EARLY DESIGN GUIDANCE OF THE EAST DESIGN REVIEW BOARD

Project Number: 3012797

Address: 802 Seneca Street

Date of Meeting: Wednesday, January 04, 2012

Alternative A

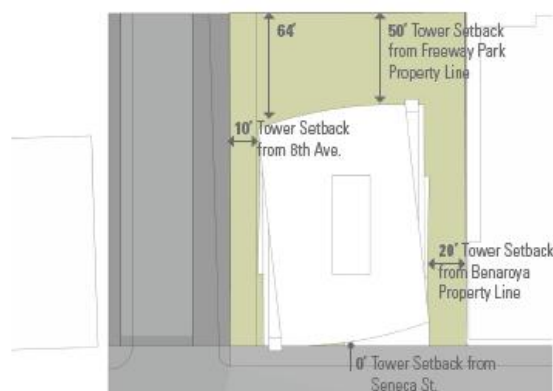
The first, and applicant-preferred scheme (Alternative A) showed a 300' tall tower located in the center of the site. Residential open space would be located at the north side of the site, level with Freeway Park, and at the rooftop. Potential materials included terracotta colored metal to respond to nearby brick and terracotta, light blue tinted glass, darker blue spandrel glass, and a mix of colors for the metal mullions. The benefits of this Alternative included a more slender tower and less building footprint than the approved MUP, more public open space at the street level, and an increased distance from the tower to the south (Royal Manor). Pros also included the ability to provide better storefront windows for the retail spaces at grade in a plaza setting, since the windows would not be cut off by the steep grades at street level. The setback from Seneca Street would allow for a better view of the Exeter House façade, as viewed from the east on Seneca Street. The applicant noted that a negative aspect of this setback is a lack of response to the context of nearby urban street walls.

The previously approved MUP included 11% open space at street level (Seneca) and Alternative A included 44% of the site as open space at street level. The potential shadows from Alternative A would be more than the approved MUP, since the change in Highrise zoning now allows for much taller buildings than in 2007. Alternative A includes less building bulk as viewed from the east and west, due to a more slender tower and removal of the north 11-story building from the proposal.

Alternative B

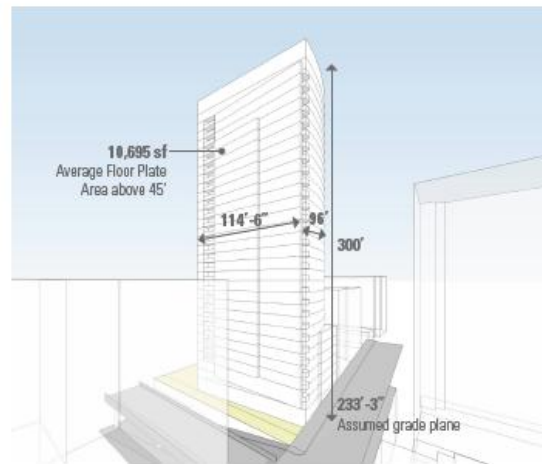
The second scheme (Alternative B) showed a similar configuration to Alternative A, but with the tower located at the south property line rather than centered on the site. The applicant noted that while this configuration responds to the nearby street wall context, it reduces privacy for the residents of Royal Manor and the proposed units, reduces the view of Exeter House, and doesn't allow room for a public plaza at Seneca Street. A positive aspect of this configuration

was a better view of Freeway Park from 8th Avenue. Residential open space could be provided on the north side of the site and at the roof.

Alternative C

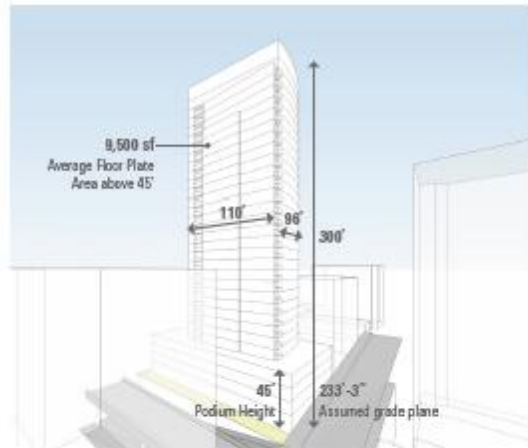
The third scheme (Alternative C) showed a tower centrally located above a 45' tall podium, as viewed from Seneca St. Pros included a response to the context of nearby street walls and a Land Use Code-conforming development. Cons included a lack of public open space at grade, reducing the view of Exeter House, a potential lack of cohesive design between the upper tower mass and the lower podium mass. Residential open space could be located at the top of the podium and the roof. This Alternative included 10 more parking spaces than Alternatives A and B.

- Alternative C is better because the street wall is a better response to nearby urban context, and the podium could offer an opportunity to design a street wall in scale with nearby context. The setback and open space alternatives are more suburban in nature and not appropriate for this site. The stepped plazas with planter walls separating sidewalk from plaza could lead to the plazas feeling proprietary rather than public.

At the Early Design Guidance Meeting, the Board discussed the context of the nearby area as described more in response to Guideline C-1. The Board agreed that some version of Alternatives C or D may be better, since it allows for a strong street wall, a building base that responds to nearby First Hill neighborhood scale, and an upper tower that responds to nearby Downtown scale.

Alternative D

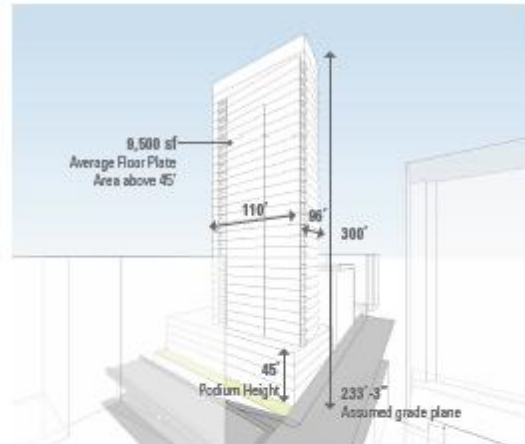
The fourth scheme (Alternative D) showed the same configuration as Alternative C, with the tower moved to the south property line. Increased parking was the same as in Alternative C. Pros and cons were listed as being the same as Alternative C.
